ISSUE: Certificate of Appropriateness for an accessory structure

LOCATION: 100-Year-Old-Building
120 North Payne Street

BAR #2021-00340
120 North Payne Street

The applicant requests a Certificate of Appropriateness to construct a carport, at 120 North Payne Street.

Figure 1 - Visibility from Cameron Street

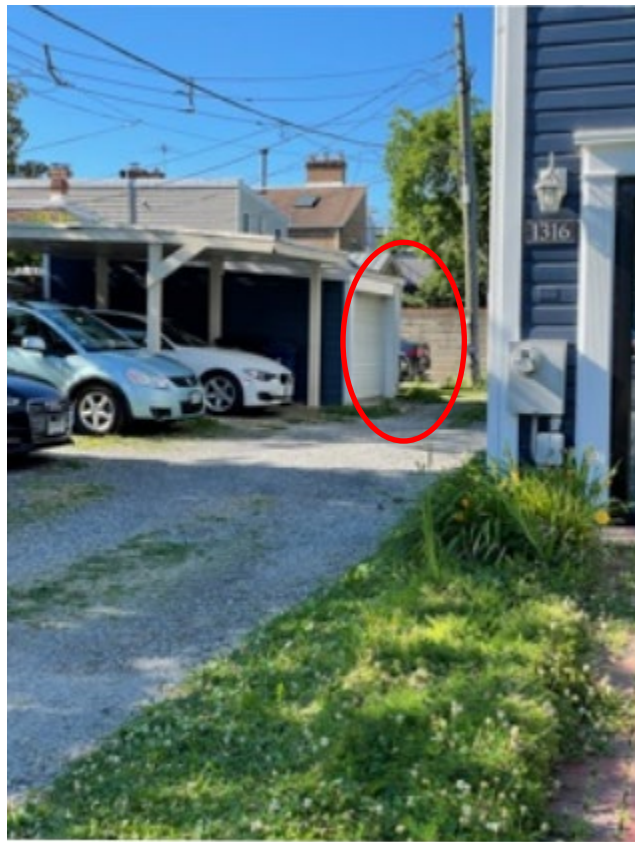
The project calls for the construction of an approximately 16'-5" D x 11'-0" W x 11'-0" H carport (197 square feet) at the rear of the subject property. The four-post with a standing seam metal roof accessory structure will be minimally visible from Cameron Street (Figure 1).

The proposed detached carport, accessory structure, is of a simpler design and materials and will be minimally visible from a public way, therefore, staff has no objections to the project and recommends approval of the Certificate of Appropriateness as submitted.
